# UNITED STATES PATENT AND TRADEMARK OFFICE

APPLICATION NO.	FILING DATE	FIRST NAMED INVENTOR	ATTORNEY DOCKET NO.	CONFIRMATION NO.
10/721,327	11/26/2003	Jiro Iizuka	018842.1279	8377

<b>Office Action Summary</b>	<b>Application No.</b> 10/721,327	<b>Applicant(s)</b> IIZUKA ET AL.	
	<b>Examiner</b> Samuel E. Belt	<b>Art Unit</b> 3746

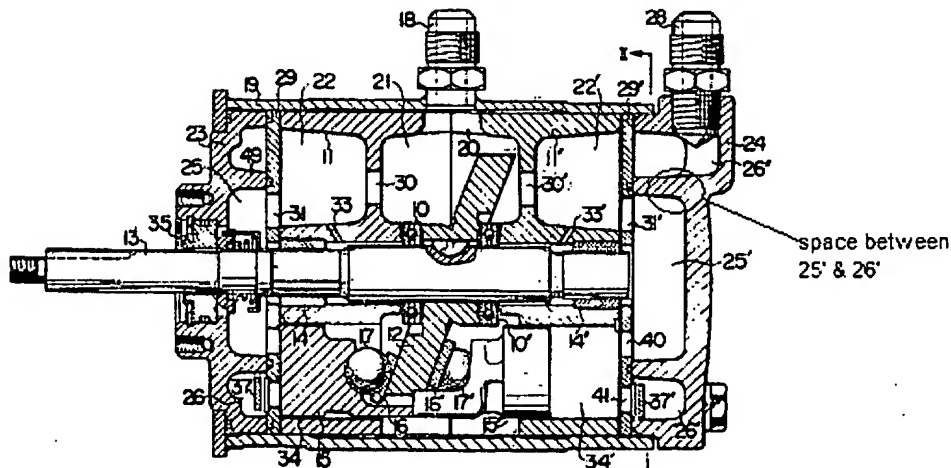
Kishi et al. in Figure 1 teaches a compressor comprising a compressor housing (11', 19) a plurality of cylinder bores (34, 34') made in the compressor housing (19) and spaced from one another in a circumferential direction of the compressor, a plurality of pistons (15, 15') reciprocally movable in the cylinder bores (34, 34') respectively, and a cylinder head (24) opposite to one end of the compressor housing and defining a refrigerant suction (25') chamber and a refrigerant discharge chamber (26') each of which communicates with the cylinder bores (34, 34'). The cylinder head (24) having a space located between the refrigerant suction chamber (26') and the refrigerant discharge chamber (25'), (**See Note**).

In the refrigerant compressor, the suction chamber (25') is at a radially center area of the cylinder head (24) while the refrigerant annular (see Figure 2) discharge chamber (26') is at a radially outer peripheral area of the cylinder head (24).

(Note: see the dividing wall that spaces chamber (25') from chamber (26') as illustrated in Figure 1 below.

Applicant's arguments filed 03/21/2006 have been fully considered but they are not persuasive because the term "space" is defined from Dictionary.com as being anything that separates or keeps apart. The dividing wall shown above clearly defines a

separation between chambers (25') and (26'), and therefore is still being considered a "space".
